DOE/EIS - 0427

Final Environmental Impact Statement

Grapevine Canyon Wind Project

May 2012

FIGURE ES.1-1

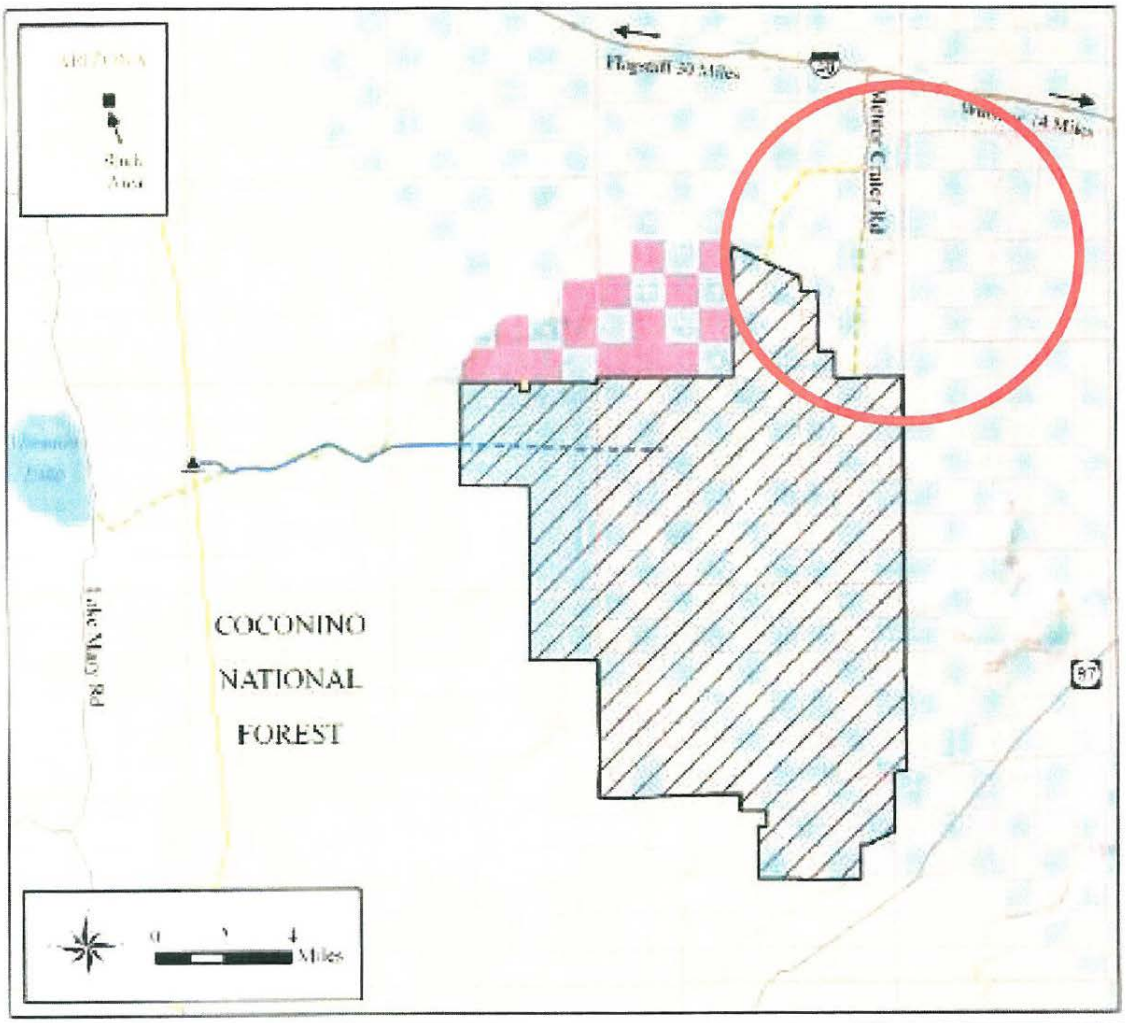
I have received the draft EIS for the Grapevine Canyon Wind Project. Upon reviewing the map, I noticed that part of the "study area" for the project included land that was within just two miles of Meteor Crater. This is of great concern to us.
